Docket Item # 9  
BAR CASE # 2008-0229

BAR Meeting  
December 17, 2008

**ISSUE:** Alterations  
**APPLICANT:** Susan Kerr, Owner  
**LOCATION:** 610 S. Pitt Street  
**ZONE:** RM / Residential Townhouse Zone

**Figure 1: Front Elevation (Proposed Slider on First Floor, Existing Metal Window on Second Floor)**

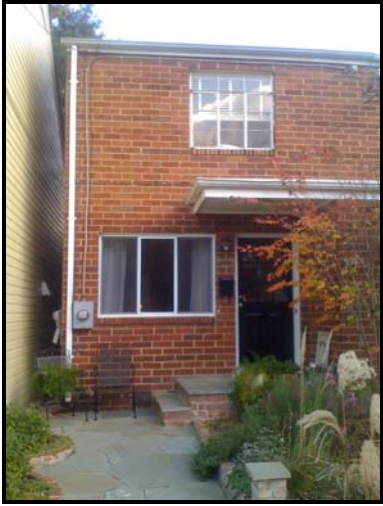
1. *After-the-fact* removal of the first floor metal, single-glazed, multi-light, fixed sash/casement window.
2. *After-the-fact* replacement of the first floor window with a double-glazed, vinyl sliding sash window.
3. The removal of the second floor metal, single-glazed, multi-light fixed sash/casement window.
4. The replacement of the second floor window with a double-glazed, vinyl sliding sash window.

S-1 Substitute metal or wood casements with true-divided lights to replace vinyl sliders.

1. Rehabilitate the existing metal, single-pane windows on the front elevation of the house and, if desired, work with BAR staff to design appropriate storm windows for weather efficiency; or,
2. Remove the existing windows on the front elevation of the house and replace them with solid metal double-pane casement/fixed sash windows, fabricated to replicate the divided-light pattern and sash composition of the existing windows. These new windows may have an applied color or a natural metal finish.
